Re: Hexcel Corporation (Hexcel)
Lodi Borough, Bergen County
ISRA Case #86009
Remedial Action Reports Dated June 30, 1998, July 27, 1998, October 23, 1998 and Remedial
Action Schedule Dated December 11, 1998

Please be advised that the New Jersey Department of Environmental Protection (NJDEP) has completed its review of the above referenced Remedial Action Reports (RARs). The NJDEP's comments regarding the Remedial Action Reports are noted below:

FIGURE 3

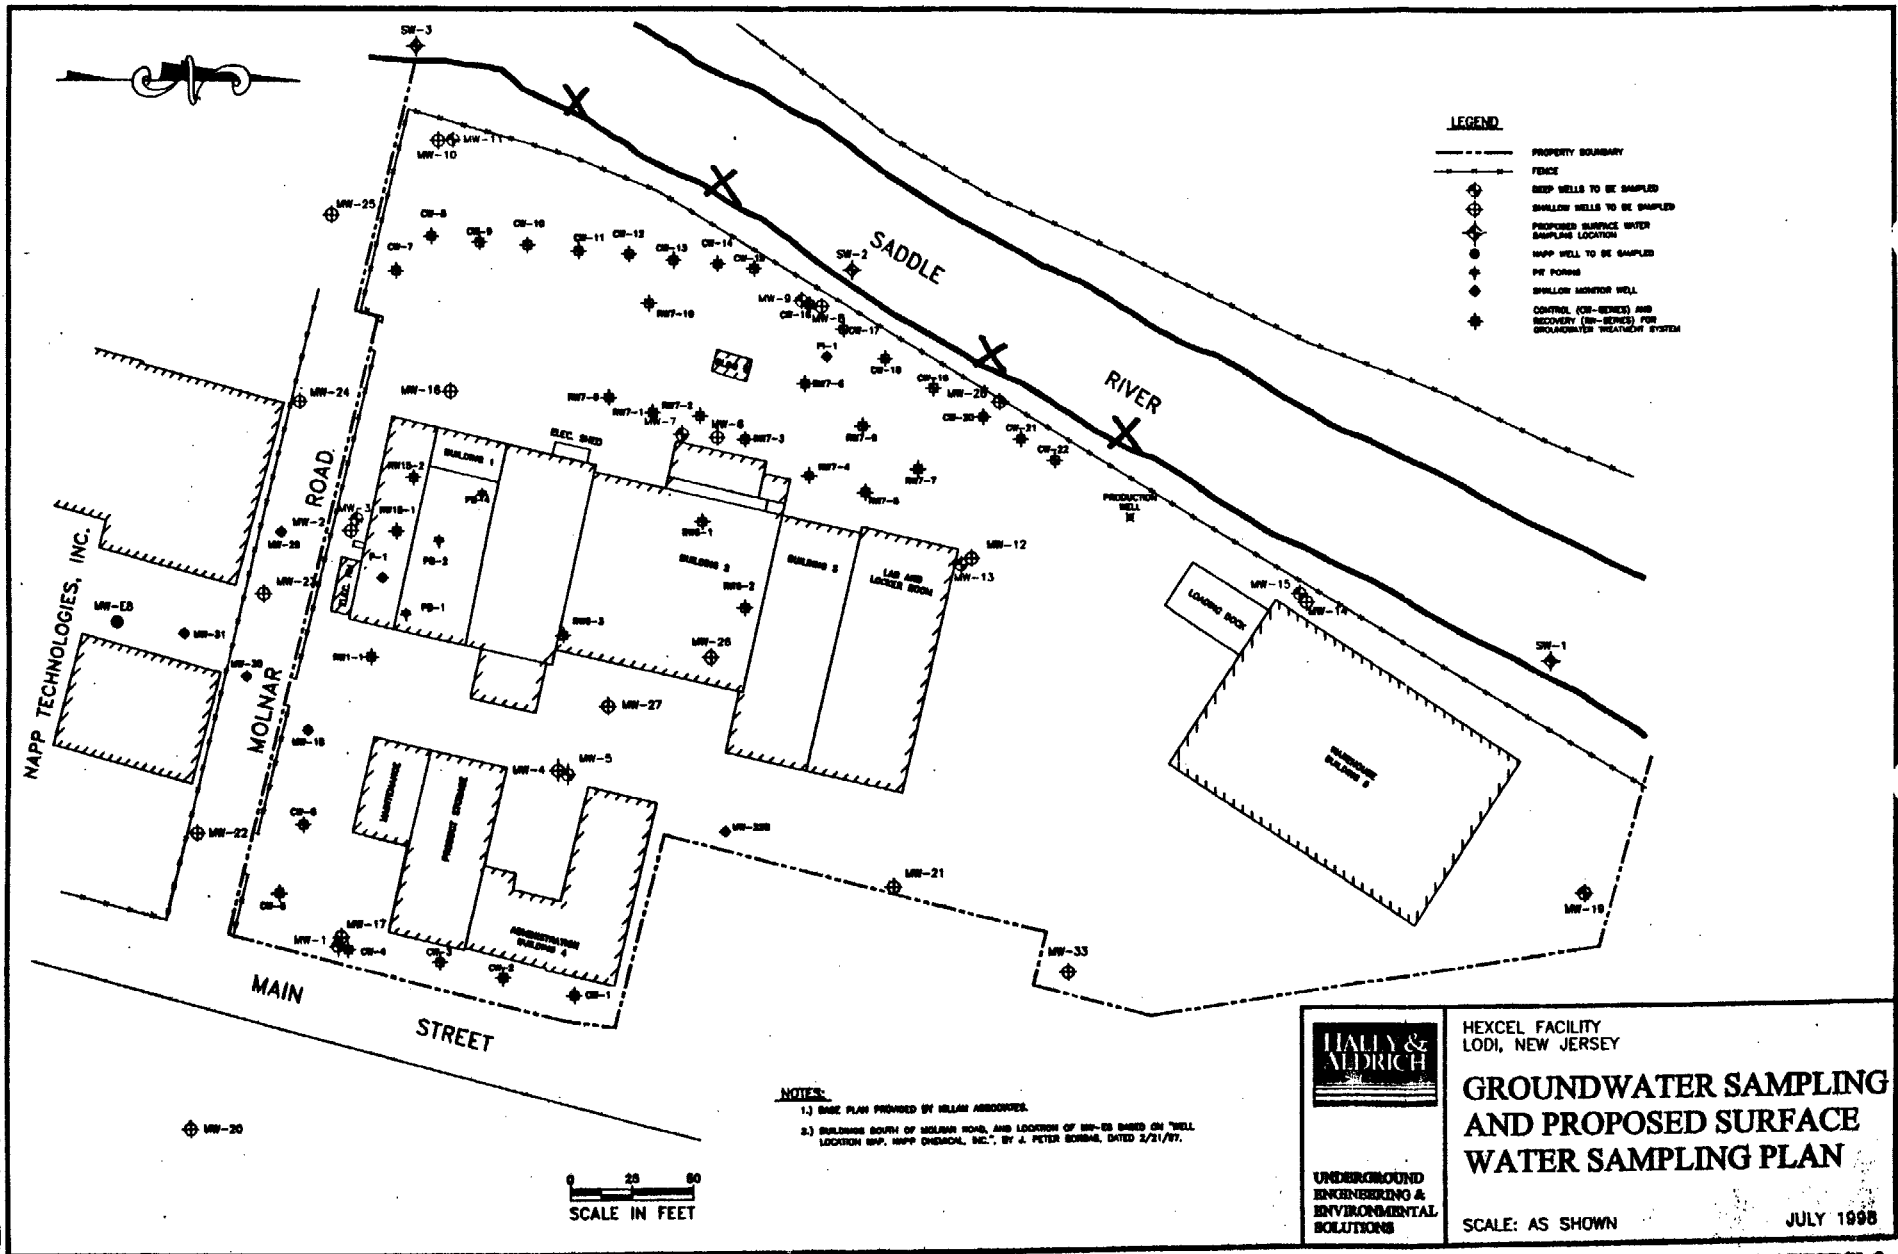
b. Hexcel shall sample the surface water at seven locations rather than at three locations as shown on the attached map. The NJDEP believes that this increased number of samples adjacent to the contaminated portion of the site is appropriate and the spacing of the required locations is consistent with the sample spacing approved for the Napp Technologies, Inc. site (approximately one sample every 60'.)

X - FOUR ADDITIONAL SAMPLE LOCATIONS REQUIRED
